South Texas Project Electric Generating Station P.O. Box 289 Wadsworth, Texas 77483

June 25, 2003  
NOC-AE-03001550  
10CFR50.55a

South Texas Project  
Unit 1  
Docket No. STN 50-498  
Request for Relief from ASME Section XI Requirements Associated with  
Characterizing Flaws in Bottom Mounted Instrument Penetration Welds  
(Relief Request RR-ENG-2-33)

**10CFR50.55a Relief Request RR-ENG-2-33**

Final Configuration  
Figure 1

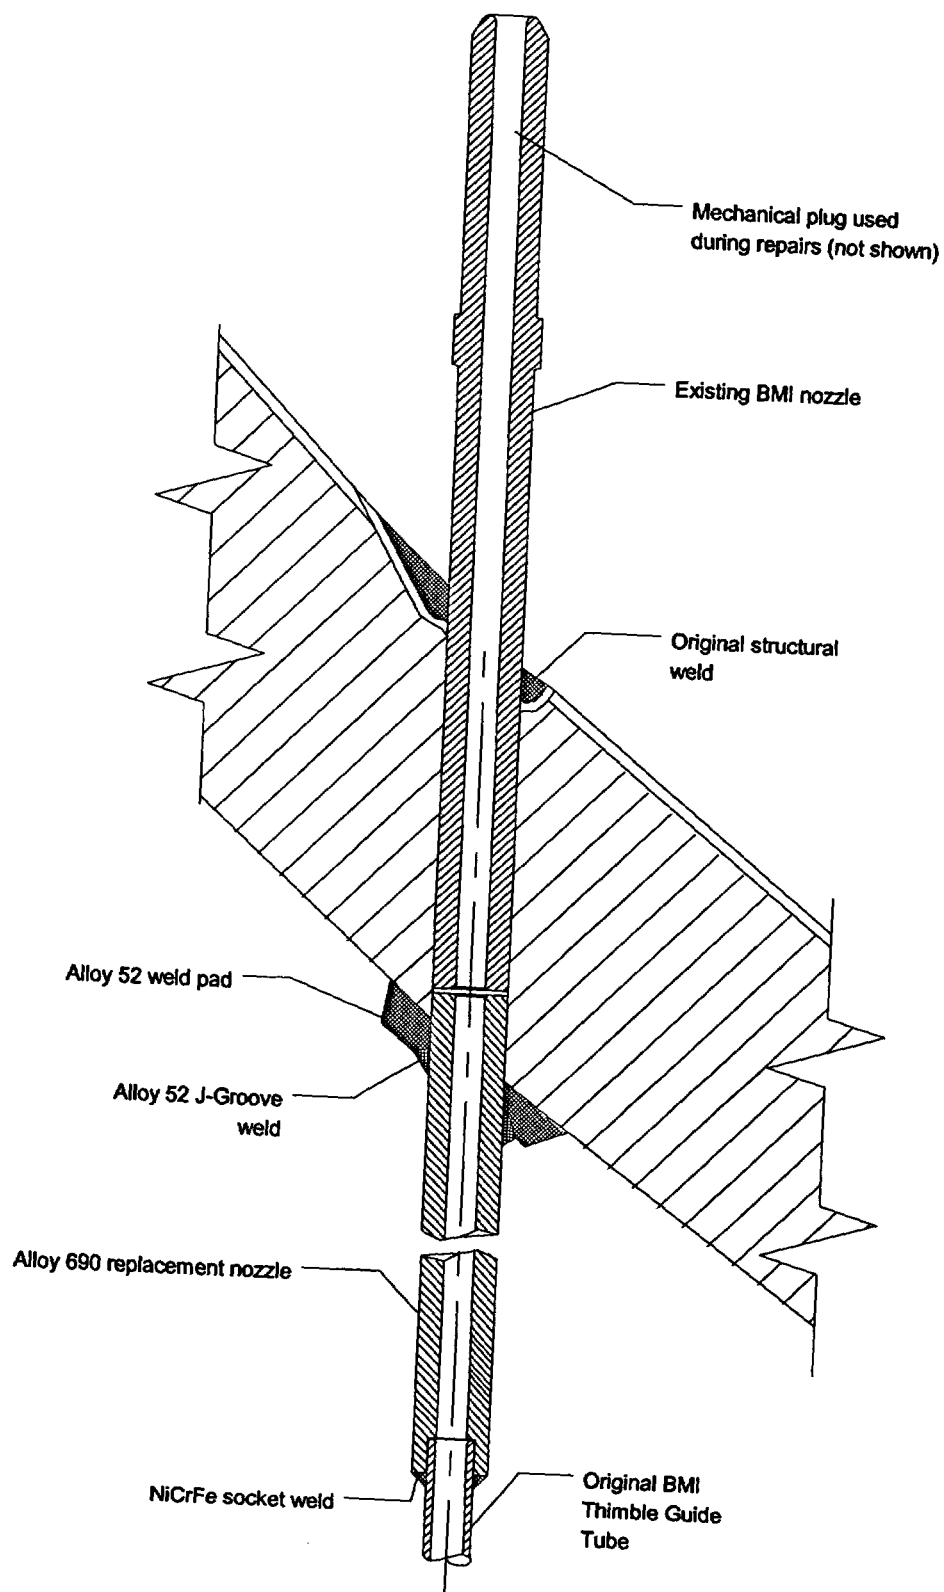
STP Nuclear Operating Company (STPNOC) conducted visual examinations of the reactor vessel BMI nozzle penetrations prior to startup from Unit 1 Refueling Outage 1RE11. These examinations revealed evidence of leakage in the annulus of two penetrations (Penetrations 1 and 46). Subsequent nondestructive examination (NDE) conducted from the nozzle bore of all penetrations confirmed the presence of flaws in the Alloy 600 nozzles of Penetrations 1 and 46 and verified no flaws existed in the nozzles of the other penetrations. The half-nozzle repair/replacement process has been implemented on the two flawed BMI nozzles. This process removed the lower portion of the BMI nozzle within and below the reactor vessel bottom head (RVBH) and replaced it with an Alloy 690 half-nozzle. A new pressure boundary J-groove weld was fabricated between the replacement nozzle and the RVBH outside surface. The upper portion of the Alloy 600 nozzle material remained in place, but it is no longer pressure retaining. The original J-groove weld on the RVBH inside surface became a non-structural attachment weld to the vessel. The final configuration is depicted in Figure 1.

Flaws may exist in the original J-groove weld and buttering of the repaired penetrations that cannot be characterized by NDE. The materials and configuration of the original J-groove weld and buttering do not permit characterization of flaws within these welds by available NDE technology. This relief request seeks approval for the two repaired BMI penetrations to remain in service without NDE characterization or successive examinations of potential flaws in the original J-groove weld, buttering, and adjacent RVBH base material based on a postulated flaw growth analysis and other bases as described below.

STPNOC proposes to accept BMI nozzle Alloy 182 J-groove and buttering weld flaws by analysis of the worst case that might exist in these welds. This analysis will provide an acceptable level of quality and safety in ensuring that the RVBH remains capable of performing its design function with potential flaws in the original J-groove weld and buttering.

In lieu of flaw characterization, ASME Section XI calculations have been performed to show the flaws are acceptable. STPNOC has postulated flaws in these welds that extend from the J-groove weld surface to the butter-to-RVBH base material interface. Based on extensive industry experience, there are no known cases where flaws initiating in an Alloy 82/182 weld have propagated into the ferritic base material.
